City of Huron  
Agenda for the Board of Building and Zoning Appeals  
Regular Meeting  
*Monday February 11th, 2019*

TO: Chairman Kath and Board Members  
FROM: Doug Green, City Zoning Inspector  
RE: 25 Cincinnati Ave.  
DATE: Friday February 1st, 2019

TO: Chairman Kath and Board Members  
FROM: Doug Green, City Zoning Inspector  
RE: 313 Bogart Rd.  
DATE: Friday February 1st, 2019

TO: Chairman Kath and Board Members  
FROM: Doug Green, City Zoning Inspector  
RE: 513 Uncas Ct.  
DATE: Friday February 1st, 2019

**A-3**

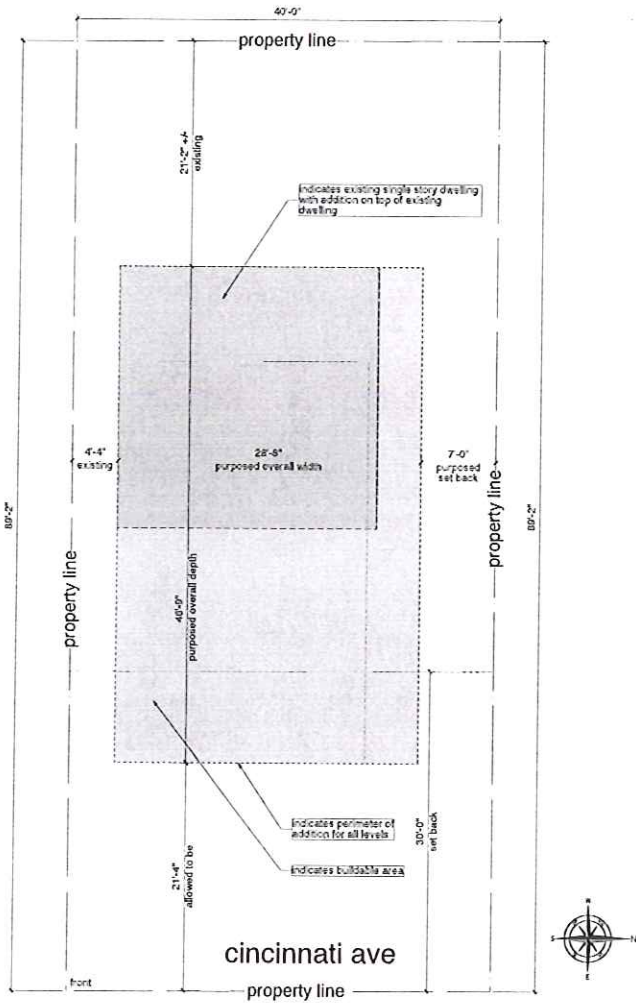
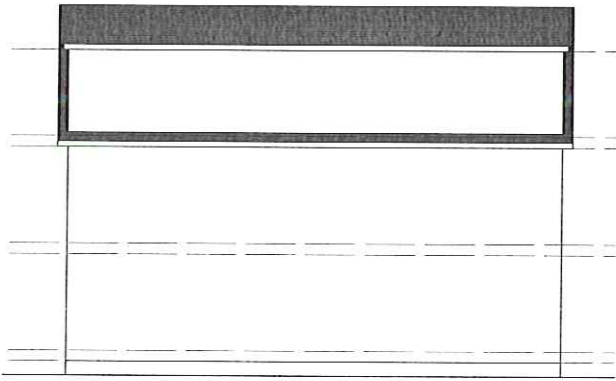
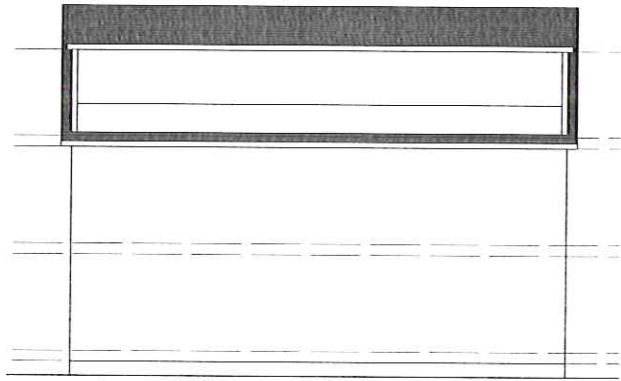
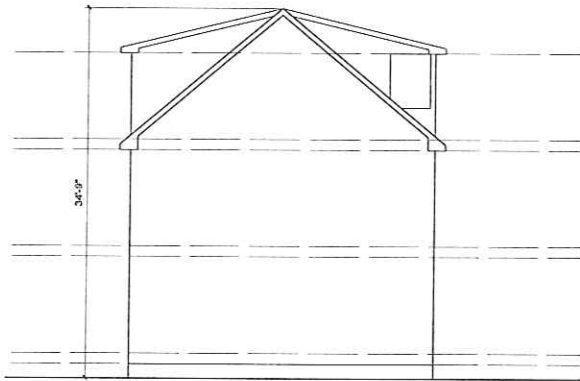
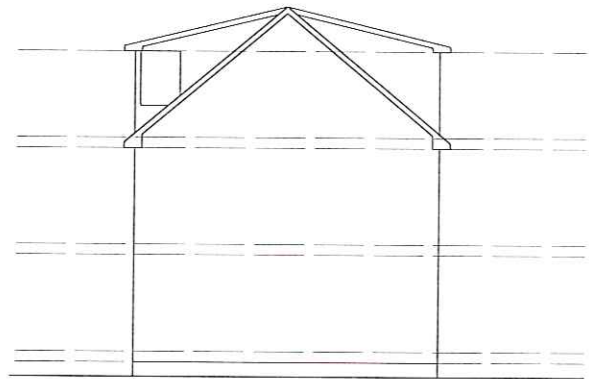
- Construction of a 3-story addition to an existing single story home
  - Variance Request: Reduction of the North Side setback by 1' for a total of 7'-0" of side setback. Per section 1123.01 the minimum side setbacks for a multi-story home are 8' and 12' for a total of 20' of side setbacks. If we designate the North side to be the 8' side this would require a reduction of the minimum setback of 1' to allow for the proposed 7' setback.

- Variance request: Reduction of the South side setback by 7'-8" for a total of 4'-4" of side setback. The existing single story home footprint is an existing non-conforming structure as the South side of the home has an existing setback of 4'-4", which for a single story home is non-conforming. The proposed addition would maintain this existing 4'-4" setback but would increase the amount by which it is non-conforming as the minimum side setback requirements enlarge from 7'/8' to 8'/12' when changing from single story to multi-story. If we designate the South side to be the 12' side this would require a reduction of the minimum setback of 7'-8" to allow for the proposed 4'-4" setback.

- Variance Request: Section 1123.01 defines the rear yard setback within an R-1 district to be 30'. The existing home is non-conforming with this code as the existing rear yard setback is 21'-2". The proposed addition will not further reduce this setback, however the portion of the proposed addition that will match this rear wall line will require a rear setback reduction of 8'-10" from the minimum allowable distance of 30'

The existing home, while non-conforming, most likely pre-dates the zoning code and is acceptable. The proposed addition, while matching the wall locations of the existing home on both the rear and the South side, is subject to the current zoning regulations and thus would require the above variances.

The proposed addition is allowable in terms of overall height: 34'-9" proposed vs 35' allowable, and front setback: 21'-4" proposed vs 20'-3" allowable. (The R-1 minimum front setback of 30' can be reduced to 20'-3" via section 1137.03 which allows a setback reduction to the average of the two adjoining neighbors.)

Parcel 42-00239.000

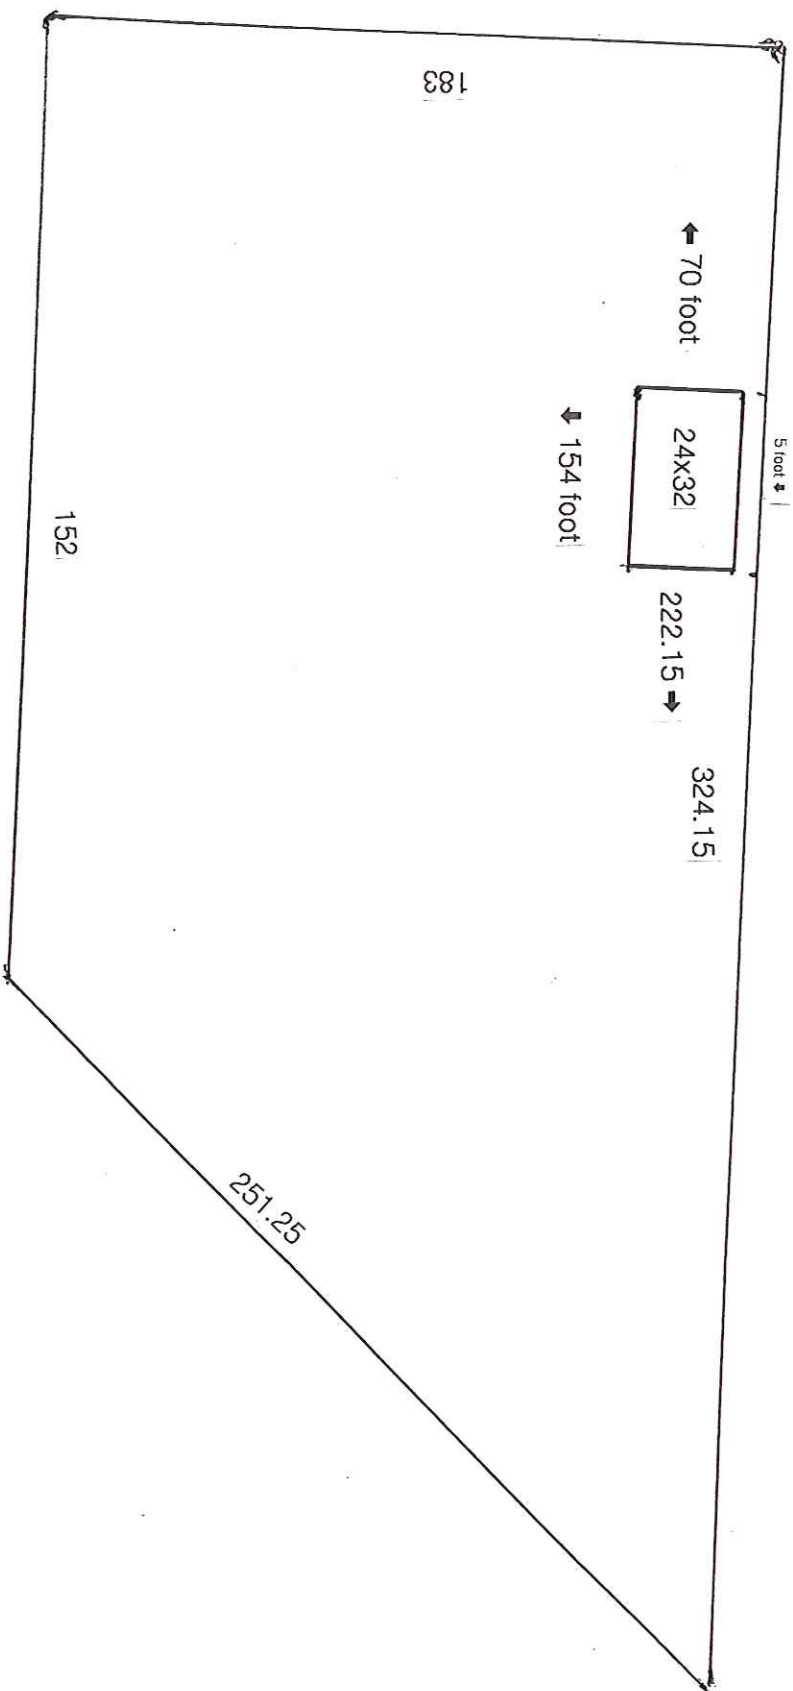
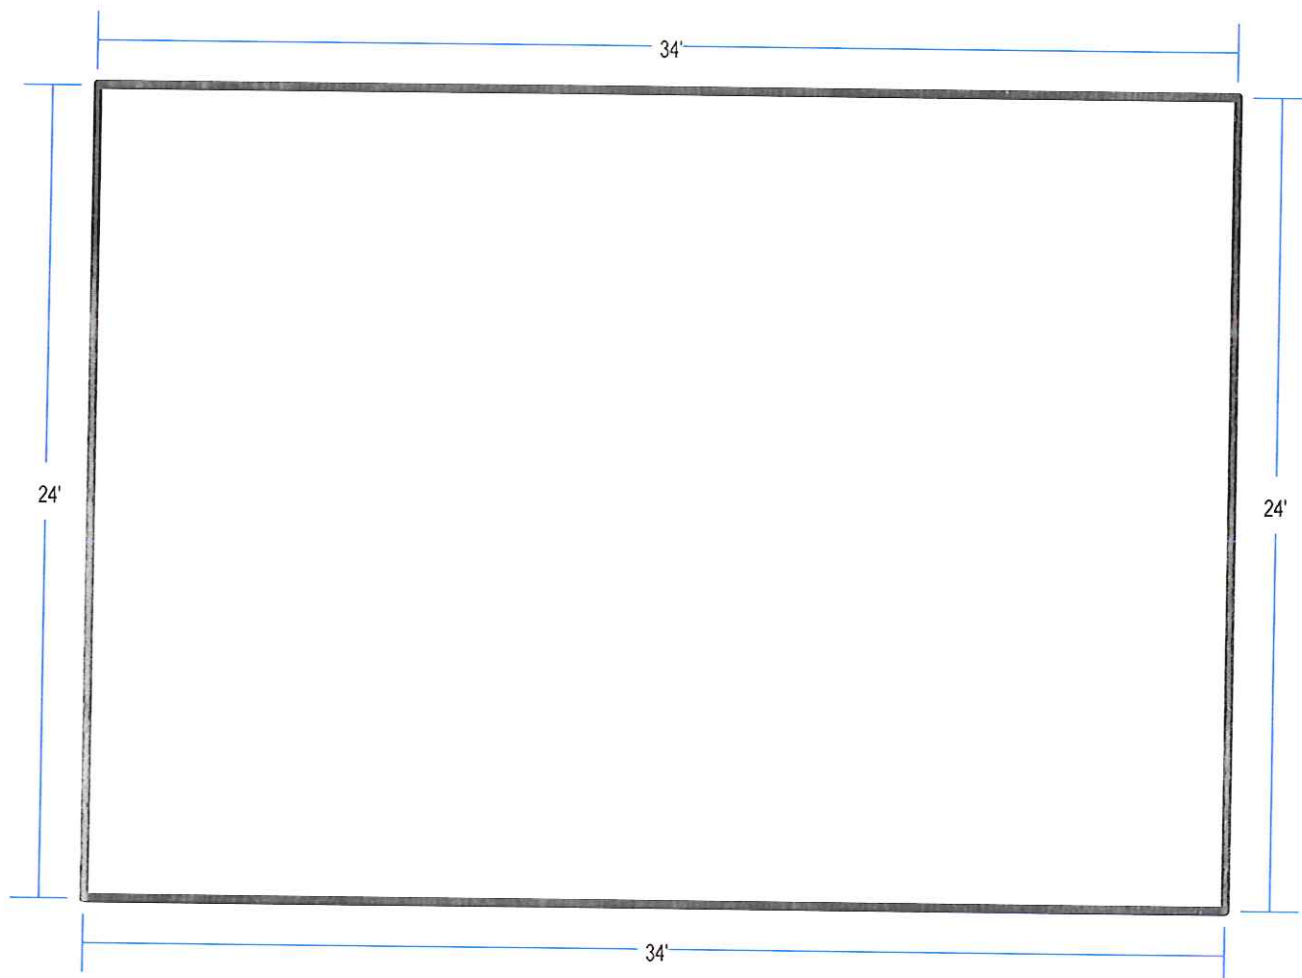
- Construction of a 24'x34' accessory building
  - Variance Request: Section 1121.06(k) of the general regulations section of the zoning code states that within any residential district no accessory building or structure shall be erected prior to the construction of the principal building. (a residential home). The lot will only contain the proposed accessory building and the applicant has no immediate plans to construct a home.

The proposed placement of the accessory structure meets all other zoning requirements in terms of setbacks and height. The only input received by the City from neighboring residents at the time of this report was from the resident who originally made the complaint about the original structure and this resident is in support of this application.

MAP OF SURVEY  
FOR  
KEN RUSH

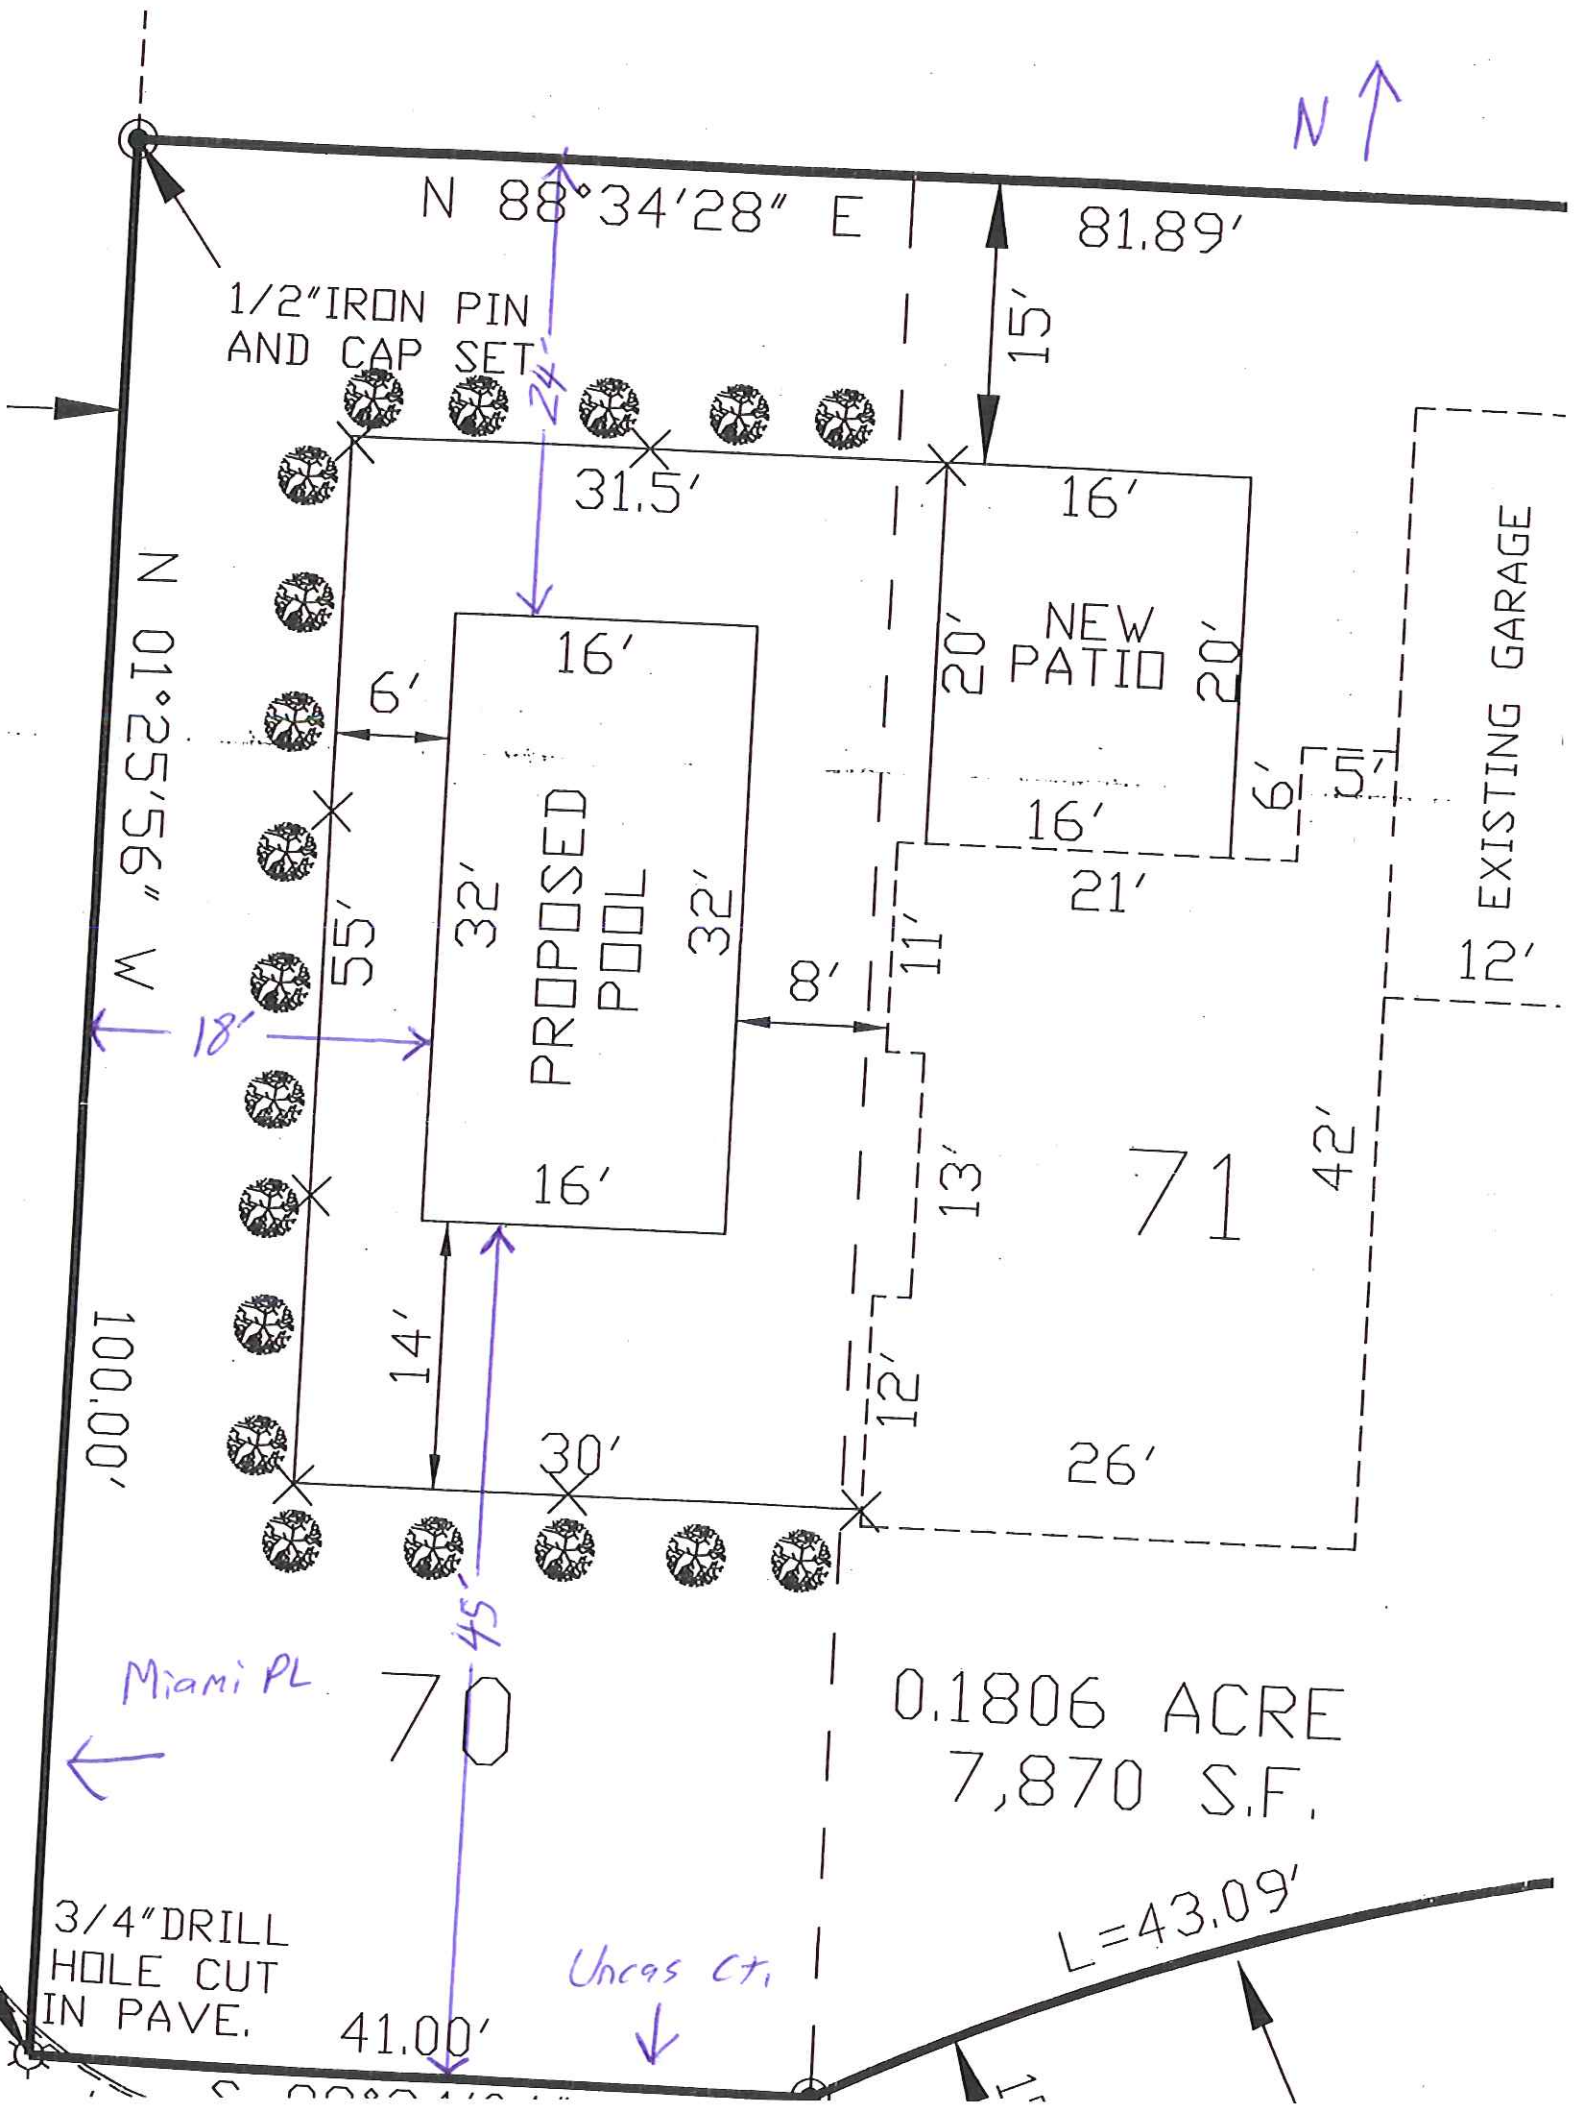
- Construction of a 16'x32' in-ground swimming pool.
  - Variance Request: Section 1121.06(i) states that in the case of a corner lot, an accessory structure (in this case a pool) must have a minimum front setback of 60' from the front lot line of the shorter of the two front lot lines. (in this case the lot line adjacent to Uncas Ct.) The proposed pool is placed a distance of 45' from the lot line adjacent to Uncas Ct which would require a front setback variance of 15' as proposed.

The proposed pool meets all other setbacks from lot lines and existing structures. The proposed 4' aluminum fencing and landscaping screening is also acceptable per code.

However, it should be noted that the proposed pool can be placed in such a way that no zoning variance would be required for approval. The lot is large enough that the pool placement could be shifted 15' to the North which would result in the minimum front setback of 60' from Uncas Ct and will have an 8' setback remaining on the Northern property line, all of which would be acceptable by code. The 'Duncan Factors' used when determining practical difficulties state that a practical difficulty cannot be established when a situation can be rectified by means other than a variance, which in this case it can by shifting the proposed placement of the pool.

The ability to place the pool without a variance was communicated to the applicant and he is aware of the situation, but would still like to request the variance in the interest of keeping the pool centered on the lot and as far away from his neighbors as possible for their benefit.
